Sent: 13/06/2022 11:28:25 AM
Subject: Objection letter - 7 Cooleena Road, Elanora Heights - DA 2022/0448
Attachments: Objection letter - DA20220448 - 7 Cooleena Road Elanora Height.pdf;

**Submission with regard to Development Application DA2022/0448
Subdivision of one lot into two and partial demolition of existing dwelling
7 Cooleena Road, Elanora Heights, NSW**

Figure 3 – Geotechnical Hazard Map

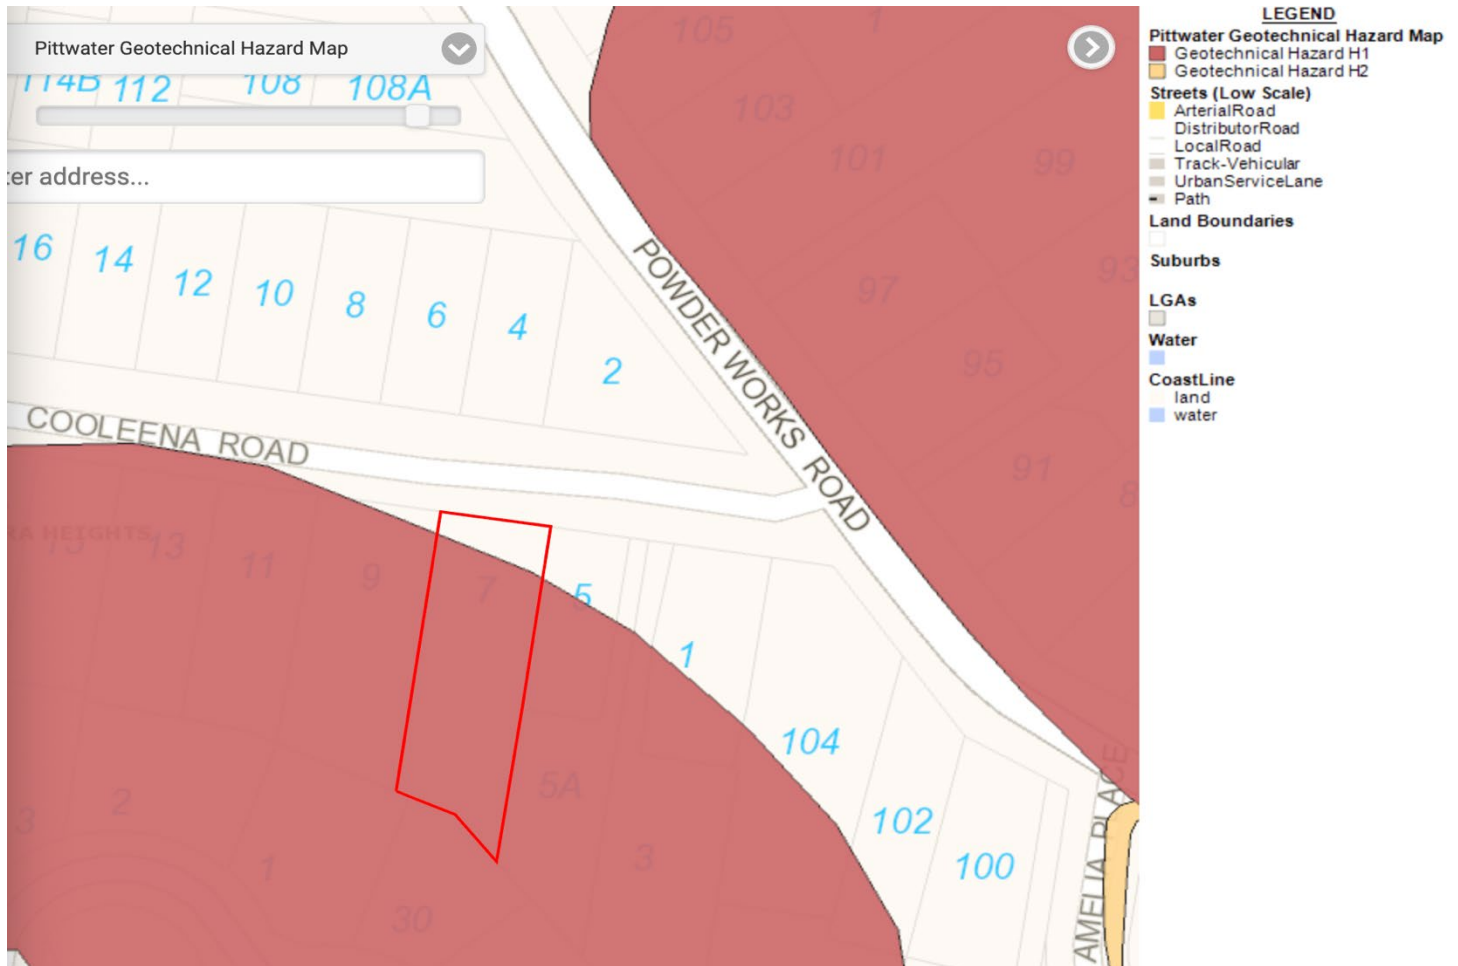
The subject site is located within Hazard Zone 1 of the Pittwater Landslip Risk, which indicates a possibility of a landslide events as, 'possible to almost certain'.

The Geotechnical Report submitted to support the proposed subdivision, identifies the risks with regard to soil instability and implications of full stormwater discharge given the topography to the site and escarpment drop off to the rear. However, the findings and potential risk to life implications are addressed by recommendations and stated limitations. As geotechnical assessment and stormwater management is not by area of expertise and given the significant risks to life, it is requested that Council Engineers are fully satisfied with the level of information submitted and associated risks to both neighbouring and future occupiers.

Although the proposed development is for the subdivision of the land, the implications from a stormwater and geotechnical assessment needs to take into account the impact of the future built form of the subject site, in accordance with Cl.4.1 and 7.7 of the LEP.
